## Product Change Notification

PCN-10631

Shell Size 3 GE Series Die-cast Backshell Design Improvement

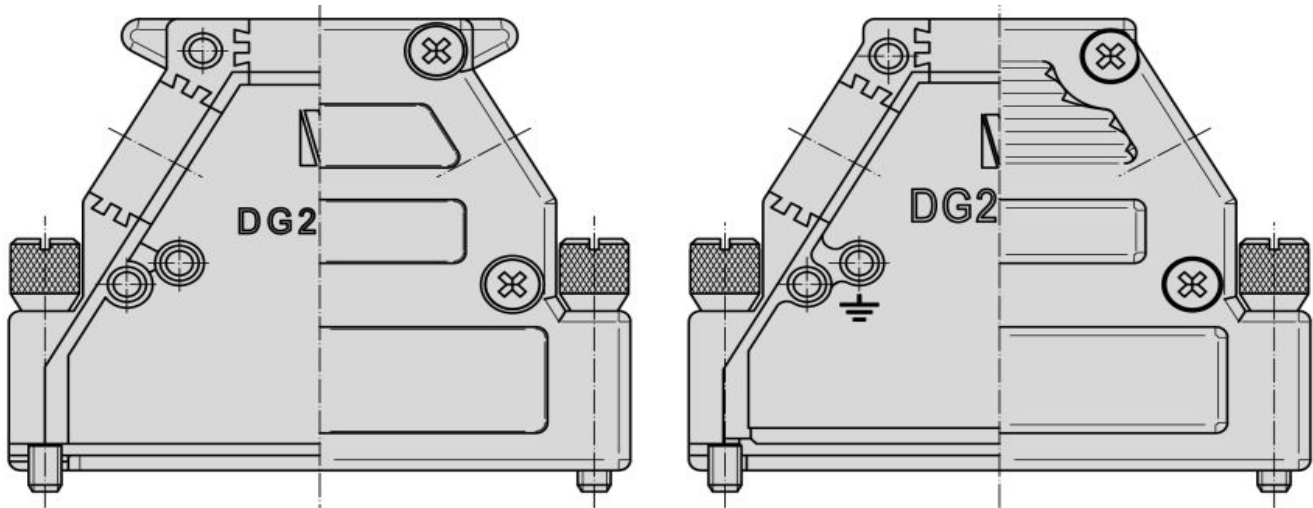
- 1) The “grip noses” on the top of the backshell have been removed.
- 2) Top cover screw hole location has shifted inward from 20mm to 19mm and downward from 37mm to 36.5mm vertical dimension to the bottom backshell opening.
- 3) Bottom backshell opening changed from 47mm to 47.3mm.
- 4) The design of the casting geometry for the backshell and cover has been enhanced, transitioning from a smooth surface to one with elevated ridges.
- 5) Bottom side clearance area for applications using a coding system has reduced from 4.4mm to 1.9mm.
